Re: PLUM Agenda December 8, 2020; Grand Avenue Signage Supplemental
Use District (Council File 20-1502) – Updated Signage Plan Exhibit

EXHIBIT A

Sign Location Plan

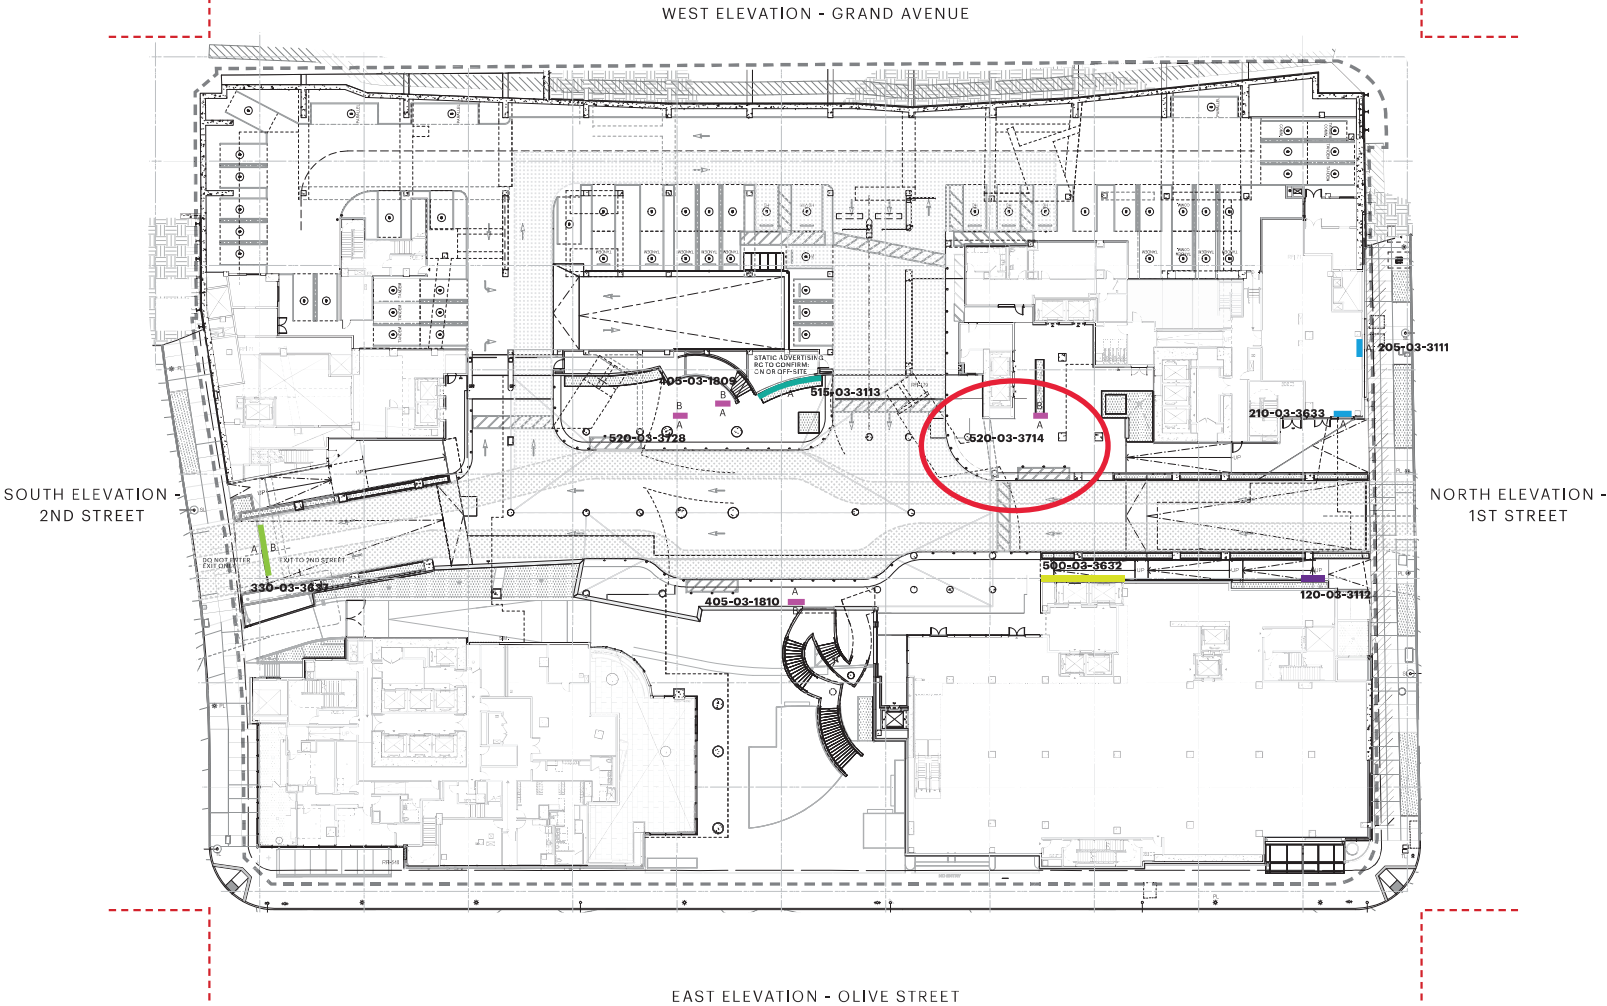
The Commission made clear at their hearing that they were not opposed to the interior signage on the valet level, which is not visible from the street. The exhibit prepared for the hearing identified the kiosk nearest the entrance, based on prior discussions with staff about identifying signage within a certain distance from the street, but that distance approach was not included in the proposed ordinance. Accordingly, the exhibit has now been updated to identify the additional interior kiosk not visible from the entrance, so that the intent of the Commission that the ordinance address all digital signage is fulfilled. The corresponding technical correction for the ordinance is for it to update the number of digital advertising kiosks from six to seven. We have enclosed an excerpted page of the updated signage plan exhibit identifying the

additional interior kiosk and an excerpted page of the ordinance with the corresponding technical correction.

2. **Height.** Advertising Kiosks shall not exceed a maximum of 13 feet in height from grade or finished floor level.
3. **Location.** A maximum of ~~six~~seven Advertising Kiosks with digital faces shall be permitted and a maximum of 12 Advertising Kiosks with no digital faces shall also be permitted.
